MILLER CREEK ESTATES SUBDIVISION,
RESUBDIVISION OF LOT 1

APPLICATION NUMBER 15 DATE July 16, 2009

APPLICANT Miller Creek Estates Subdivision, Resubdivision of Lot 1

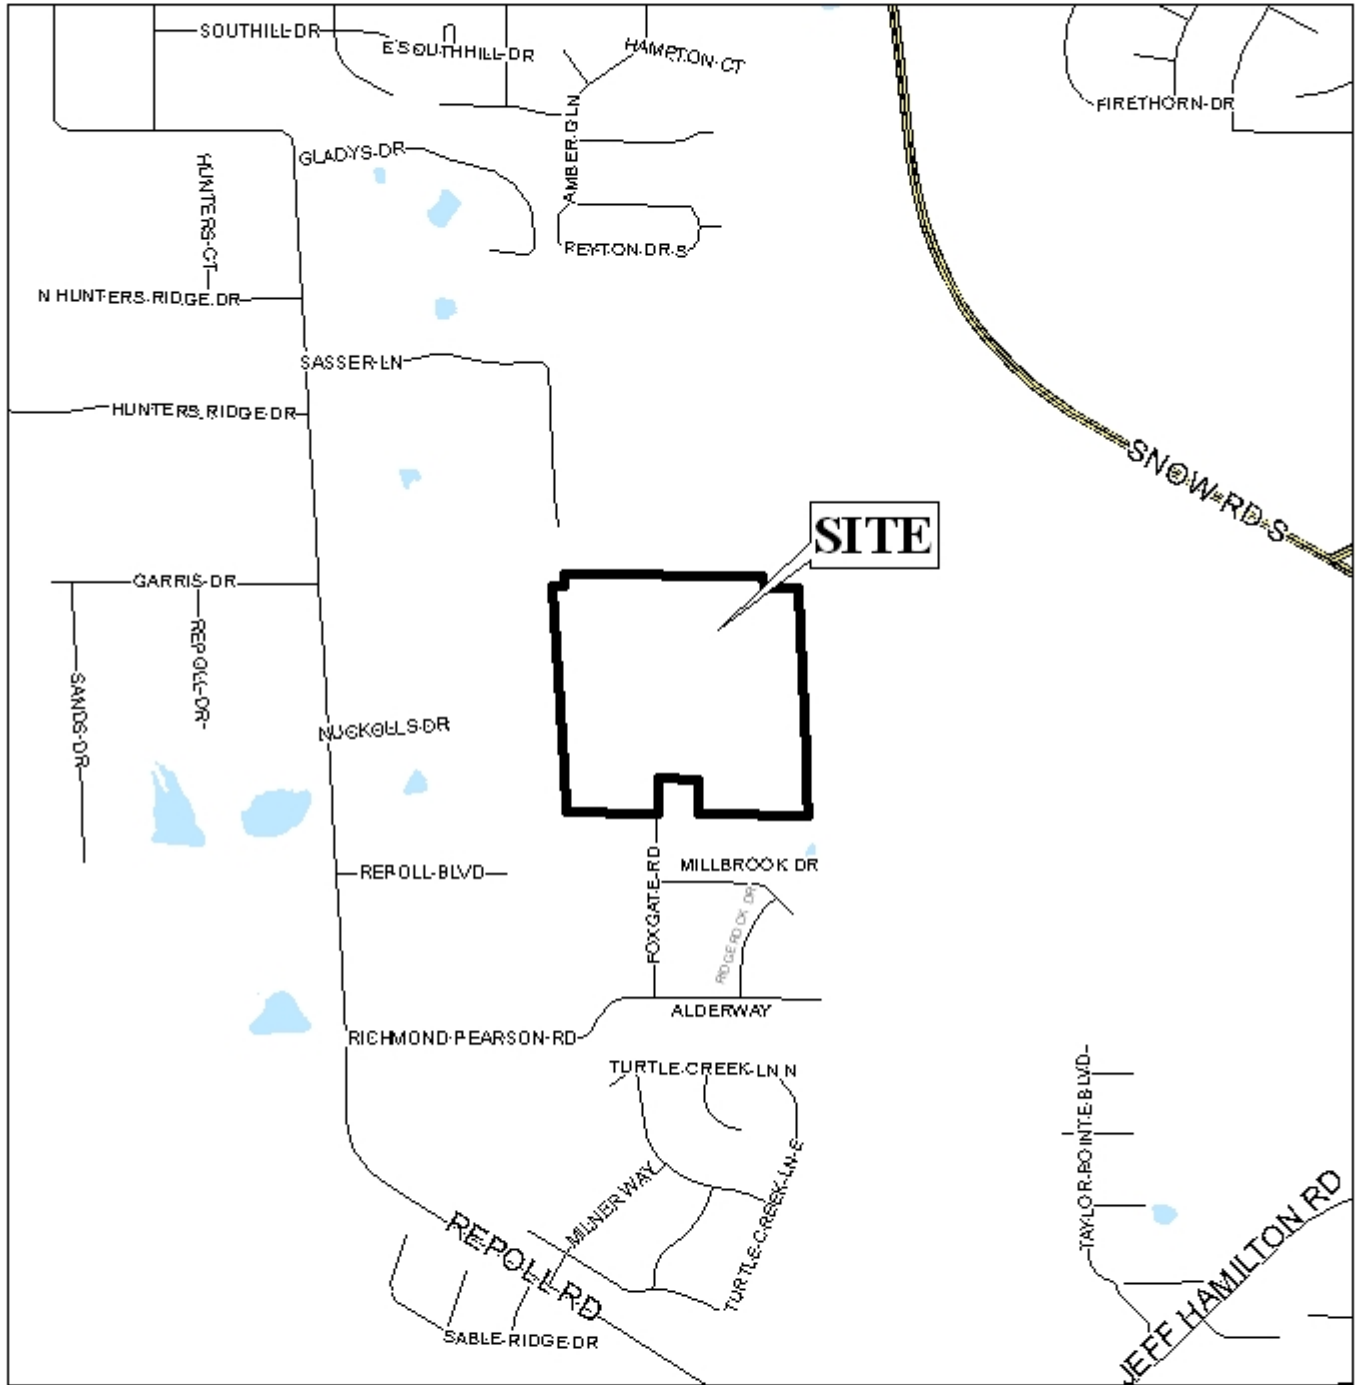
The proposed development will increase the number of lots fronting onto Sasser Lane, which is currently a street stub. It is recommended that dedication adequate to provide right-of-way for a closed-end street be provided, thus the plat should be revised to show dedication adequate to provide a 120-foot diameter right-of-way. An inquiry with Mobile County Engineering

The 25-foot minimum building setback is not shown on the plat. The required setback should be depicted around any portion of Lot 1-A abutting a street-stub, and around that portion of Lot 1-B where the "pole" meets the "flag" portion of the lot. The setback line should also be labeled.

The lot size information on the preliminary plat should be retained for the final plat, adjusted for any right-of-way dedication.

Finally, the applicant provided no justification for the proposed flag lot. As previously mentioned, however, the site is bisected by floodplains and wetlands associated with Miller Creek, thus there are substantive natural barriers that impact the site. The size of the site would allow, however, redesign of the proposed lot lines to eliminate the proposed flag lot configuration.

- 1) Provision of documentation that Sasser Lane is maintained by Mobile County for its entire length;
- 2) Revision of the plat to show provision of a 120-diameter cul-de-sac at the terminus of Sasser Lane, and revision of lot sizes to accommodate the cul-de-sac;

- 4) Depiction of the 25-foot minimum building setback line as discussed in the report;
- 5) Placement of a note on the plat stating that: "Development must comply with the Mobile County Flood Damage Prevention Ordinance. Development shall be designed to comply with the storm water detention and drainage facility requirements of the City of Mobile storm water and flood control ordinances, and requiring submission of certification from a licensed engineer certifying that the design complies with the storm water detention and drainage facility requirements of the City of Mobile storm water and flood control ordinances prior to the issuance of any permits."

- 10) Provision of justification for the flag-shaped lot.
